<b>Docket Number:</b>	15-AAER-06
<b>Project Title:</b>	Small Diameter Directional LED Lamps and General Purpose LED Lamps
<b>TN #:</b>	206867
<b>Document Title:</b>	CA IOU Comments on Small Diameter Directional Lamps
<b>Description:</b>	N/A
<b>Filer:</b>	System
<b>Organization:</b>	CA IOU/Michael McGaraghan
<b>Submitter Role:</b>	Public
<b>Submission Date:</b>	12/7/2015 4:15:54 PM
<b>Docketed Date:</b>	12/7/2015

## **CA IOU Comments on Small Diameter Directional Lamps**

# Small Diameter Directional Lamps

**RESPONSE TO CEC'S EXPRESS TERMS 45 DAY  
LANGUAGE PROPOSAL**

**Figure 3. Alternate Proposal for SDDLs Incorporating a Minimum CRI**

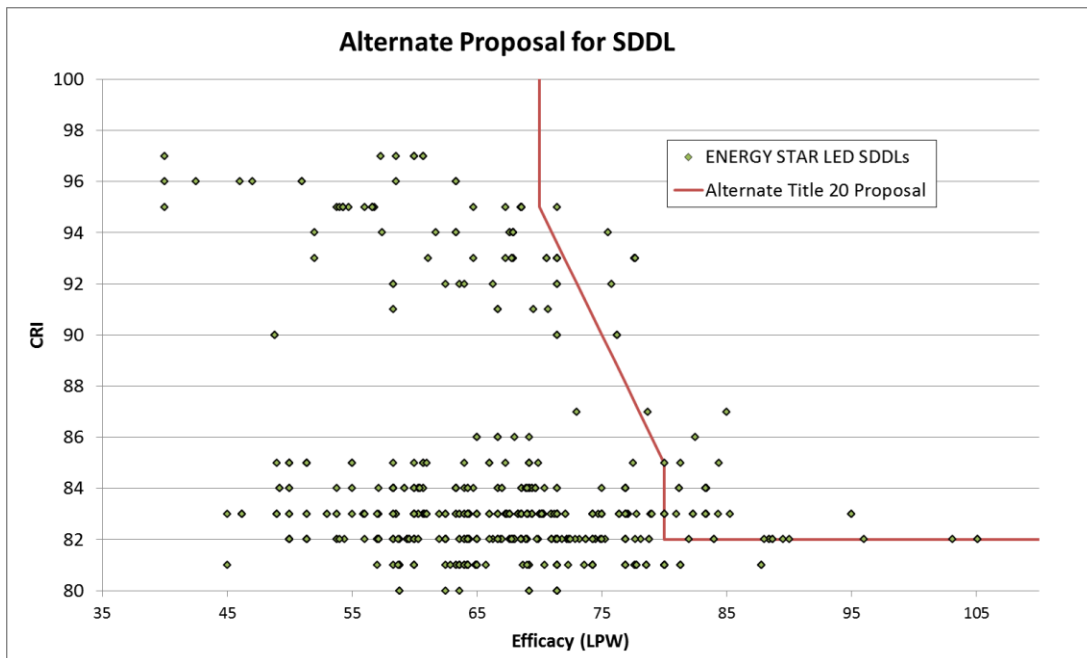
We recommend that CEC add a minimum CRI requirement for small diameter directional lamps. As written in the 45 day language, the proposal does not have any minimum CRI requirement for lamps as long as they have an efficacy above 80 lpw. This means that a manufacturer could potentially sacrifice product utility as a way to more easily meet the efficacy requirements. A manufacturer might find a lower cost way to achieve 80 lpw simply by reducing color rendering dramatically (for example to 50 or 60 CRI), which would have negative consequences. CRI is not required to be provided on SDDL packaging so consumers may not be aware that a product has such low color rendering properties. This would likely result in significant consumer disappointment with their purchase, and backlash to the implementation of this Title 20 standard.

For consistency with the LED Lamps proposal, we recommend setting a minimum CRI of at least 82 for SDDL. The simplest way to make the changes to the 45 day language would be as follows (underlined in red):

(3) State-regulated Small Diameter Directional Lamps. State-regulated small diameter directional lamps manufactured on or after January 1, 2018 must have a CRI of at least 82, a rated life of 25,000 hours or greater as determined by the lumen maintenance and time to failure test procedure and meet one of the following requirements:

- (A) have luminous efficacy of  $\geq 80$  lumens per watt.
- (B) have a minimum luminous efficacy of 70 lumens per watt or greater and a minimum compliance score of 165 or greater, where compliance is calculated as the sum of the luminous efficacy and CRI.

This change would result in the standard line that appears in Figure 3, below.
